7.0 Instrumentation and Control Systems

7.1 Introduction

The information in this section of the reference ABWR DCD, including all subsections and tables, and figures, is incorporated by reference with the following departures and supplements.

Figure 7.1-1 ~~SSLC Self-Test System~~ Diagnosis

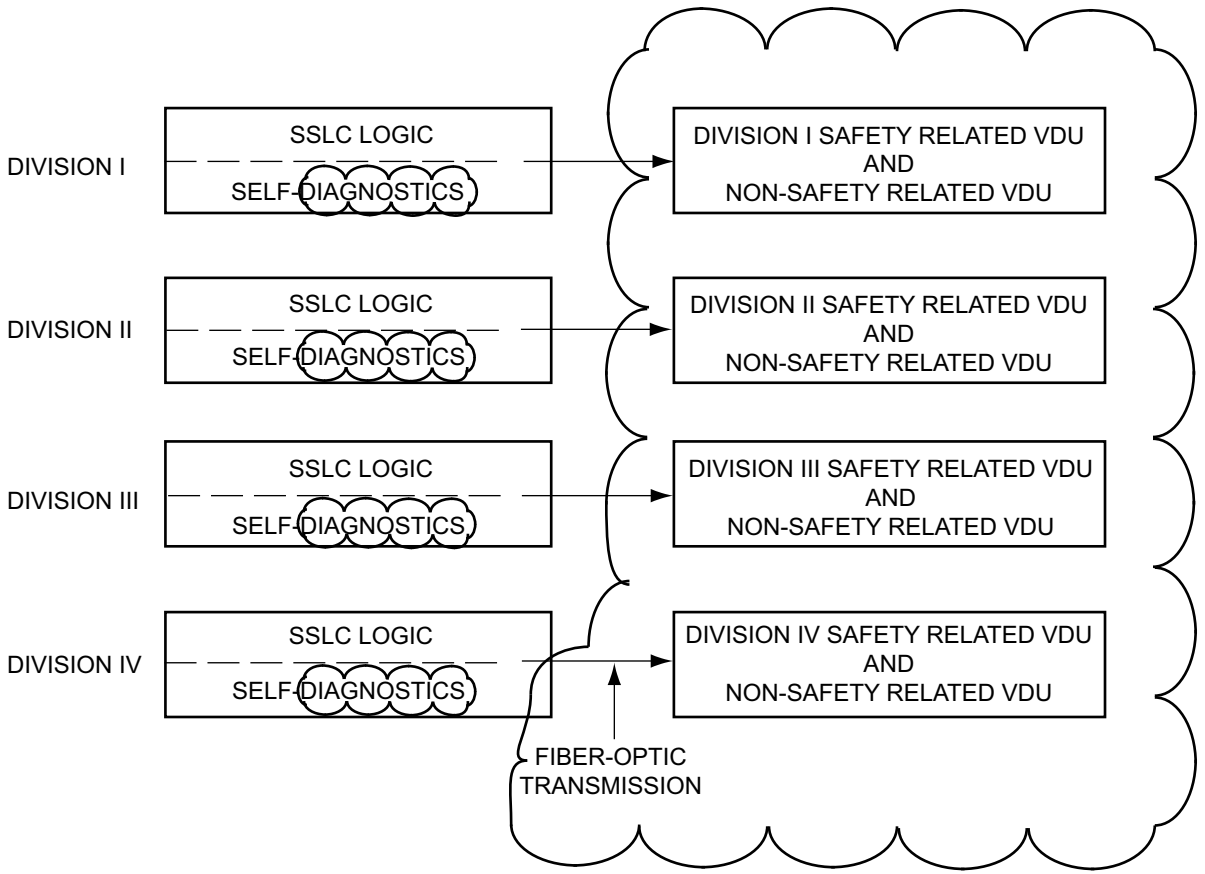
STD DEP T1 3.4-1 (Figure 7.1-1, 7.1-2)

STD DEP T1 3.4-1

Each individual safety-related system utilizes redundant channels of safety-related instruments for initiating safety action. The automatic decision making and trip logic functions associated with the safety action of several safety-related nuclear steam supply systems (NSSS) are accomplished by ~~a four-division correlated and separated protection logic complex called the safety system logic and control (SSLC)~~. The SSLC includes multiple redundant divisions, which are separated from each other. The SSLC has four redundant divisions of sensors. Each division of sensors has a corresponding division that determines the trip status of the safety functions relative to the safety function setpoint. The SSLC has four redundant divisions for all actuation functions except for the engineered safety features. The engineered safety features have three divisions, corresponding to the maximum redundancy of the engineered safety features actuated components. Some engineered safety features functions are less than three-fold redundant and are assigned to the appropriate set of redundant divisions. The SSLC multi-divisional complex includes divisionally separate control room and other panels which house the SSLC equipment for controlling the various safety function actuation devices. The SSLC receives input signals from the redundant

Figure 7.1-2 Assignment of Interfacing Safety System Logic to SSLC Controllers

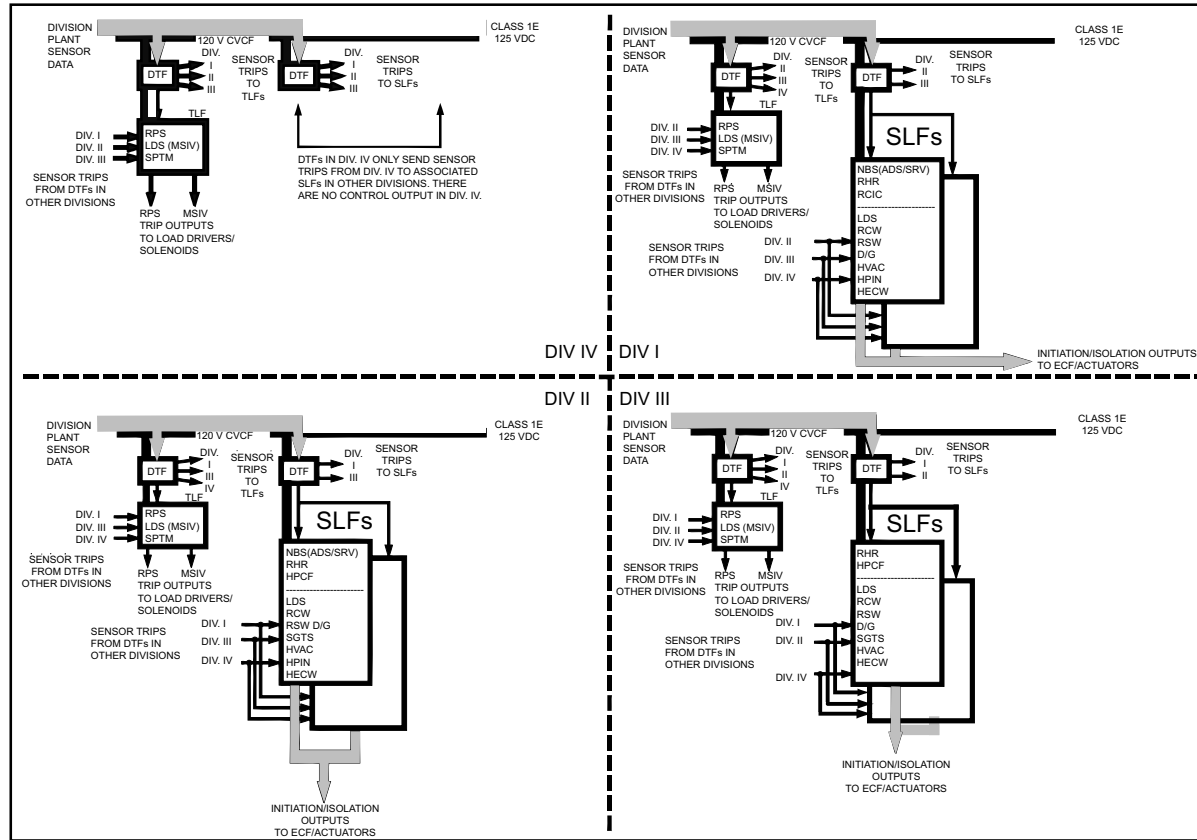
~~Divisional separation is also applied to the essential multiplexing system (EMS), which provides data highways for the sensor input to the logic units and for the logic output to the system actuators (actuated devices such as pump motors and motor operated valves). Systems which utilize the SSLC are include: (1) Reactor Protection (trip) System; (2) High Pressure Core Flooder System; (3) Residual Heat Removal System; (4) Automatic Depressurization System; (5) Leak Detection and Isolation System; (6) Suppression Pool Temperature Monitoring System; and (7) Reactor Core Isolation Cooling System. The equipment arrangement for these systems and other supporting systems is shown in Figure 7.1-2.~~

1. NMS AND PRM (NOT SHOWN) ARE STANDALONE SYSTEMS WITH TRIP OUTPUTS TO RPS AND ESF CONTROLLERS OF SSLC
2. POWER SOURCES (PER DIVISION)
 ECF: CLASS 1E, 125 VDC and 120 CVCF
 ESF: CLASS 1E, 125 VDC
 RPS/MSIV: CLASS 1E, 120 CVCF
 NMS/PRM: CLASS 1E, 120 CVCF
